Work Order ID 60269

Item Name: Basket Hoop

DESIGN #	DRAWN BY CP	DART AEROSPACE LTD HAWKESBURY, ONTARIO, CANADA	
CHECKED #	APPROVED #	DRAWING NO. D3166	REV. A SHEET 1 OF 1
DATE 02.07.10		TITLE BASKET HOOP	SCALE NTS
A	02.07.10	NEW ISSUE	
A1	04.04.08	38+-1 WAS 36.0

DRAWING NO. D3166	TITLE BASKET HOOP	REV A1	DART AEROSPACE LTD ENGINEERING ORDER		D.E.O. NO. D3166-A-2	SHEET NO. 1 OF 1	SCALE NTS
DRAWN AJS	CHECKED <i>[Signature]</i>	MFG. APPR. <i>[Signature]</i>	APPROVED <i>[Signature]</i>		DE APPR. <i>[Signature]</i>		
DATE 08.12.11	DATE 08.12.15	DATE 08/12/15	DATE 08/12/16		DATE 08.12.16

D3166-1 BASKET HOOP

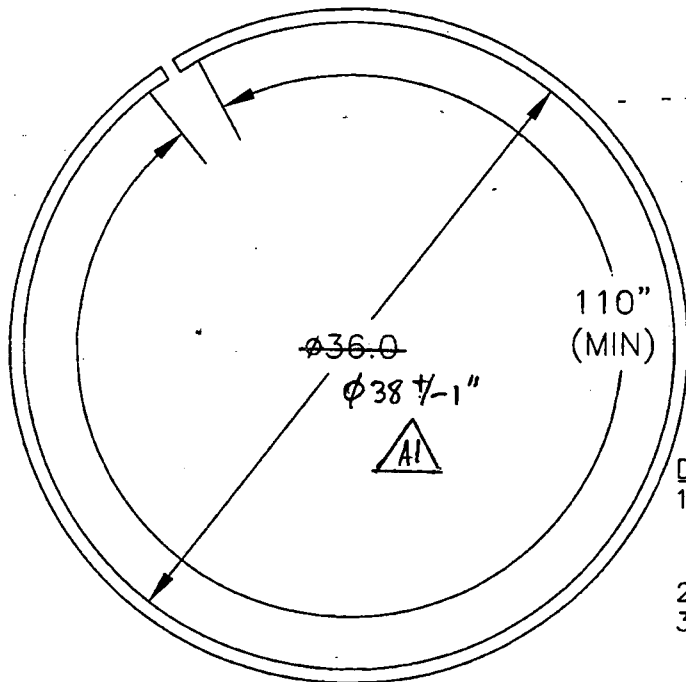
10.6 (REF, NEED 8.0 MIN)

1) MODIFY MATERIAL NOTE FOR D3166-1 AS SHOWN:

2) MODIFY MATERIAL NOTE FOR D3166-3 AS SHOWN:

IS:

1) MATERIAL: AISI 304/316 SS, 3/4 X 3/4 X 0.065 WALL SQUARE TUBING,
60.00" LONG
REF. DART SPEC M304TS0.750W.065

WAS:

1) MATERIAL: AISI 304/316 SS SQUARE TUBING,
0.75" x 0.75" x 0.063 WALL, 60.00" LONG
(REF DART SPEC. M304TS0.750W.063)

IS:

1) MATERIAL: AISI 304/316 SS, 3/4 X 3/4 X 0.065 WALL SQUARE TUBING,
120.00" LONG
REF. DART SPEC M304TS0.750W.065

WAS:

1) MATERIAL: AISI 304/316 SS SQUARE TUBING,
0.75" x 0.75" x 0.063 WALL, 120.00" LONG
(REF DART SPEC. M304TS0.750W.063)
